Job No: 2020-4359
Job Title: Euston One, William Road, Euston
File Ref: CA4359-N02-DR-Transport Response Note LBC (210518).docx
Date: 18th May 2021

Subject: 2020/5473/P: 17-37 William Road, LB Camden
Response to LB Camden's Highways and Transportation Comments and Queries

Stair Isometric (NTS)

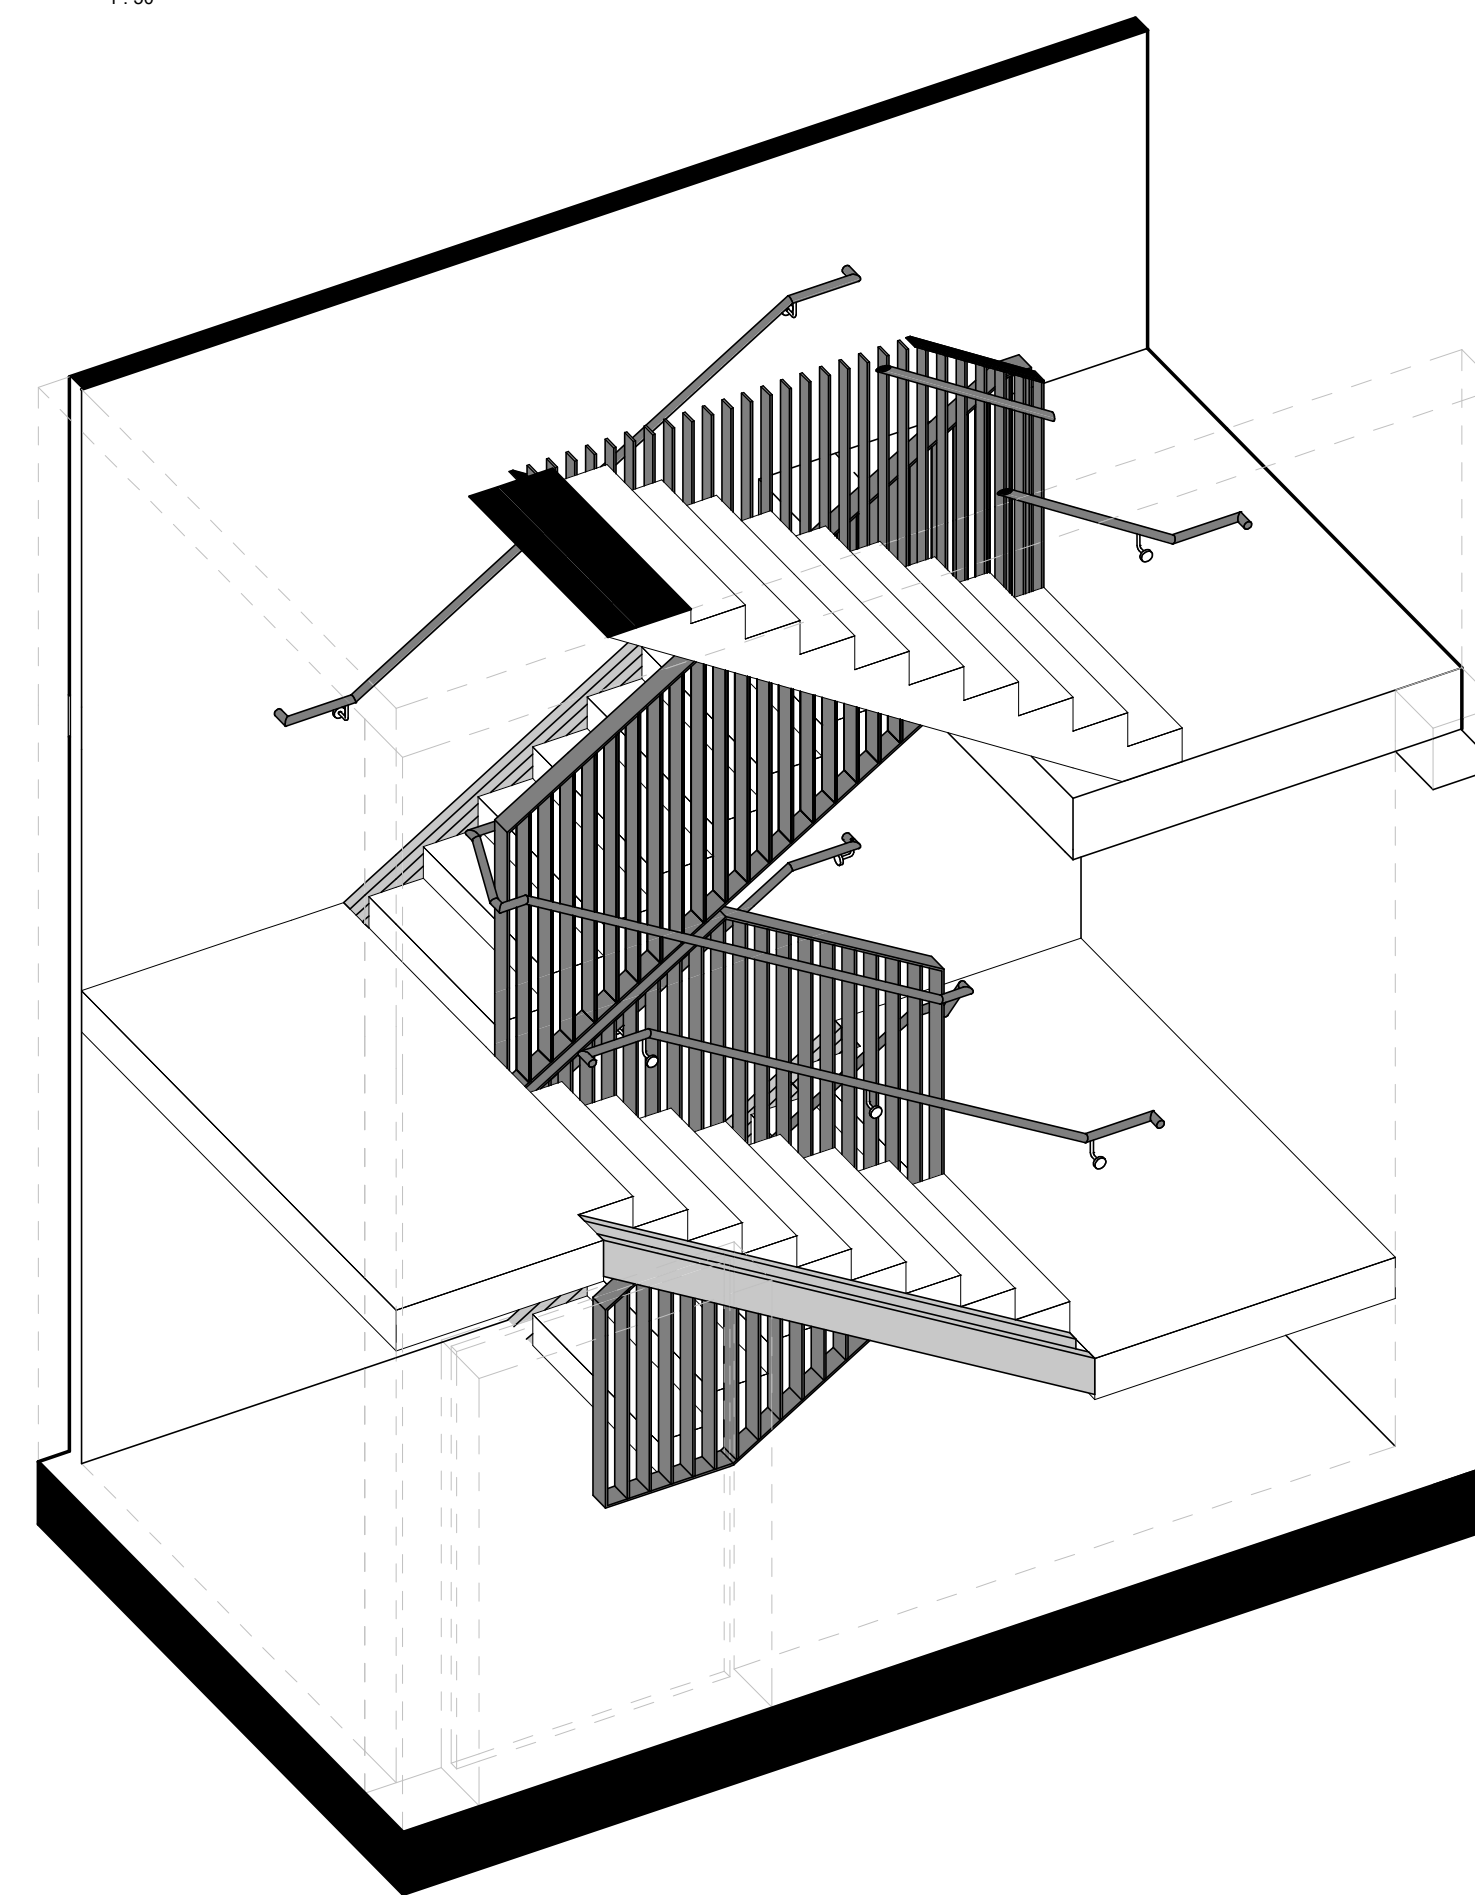
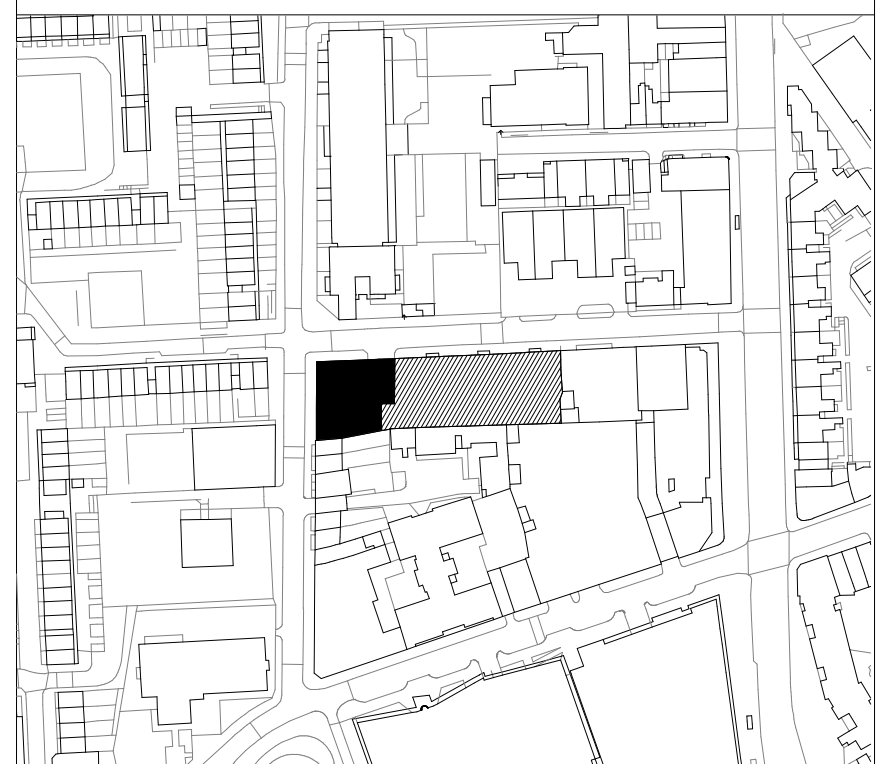
The Stair Ramp needs to be shown on the drawings.

The TA refers to: *Two-Tier Racks at Basement Level accessed via Lift or Stair Ramp.* The Stair Ramp needs to be shown on the drawings. It should be noted that the dimensions of the proposed lifts fall short of the requirements of CPG Transport clause 8.16: *The route to cycle parking from street level must be step free. If level access is unachievable, the cycle parking must be accessible via a ramp or a lift that is adequate in size to accommodate a cycle and its user. Lifts should measure a minimum of 2m x 2m, although where many users are likely to arrive at a similar time, for example at a large*

21. **Appendix C** includes a drawing showing the Stair Ramp.
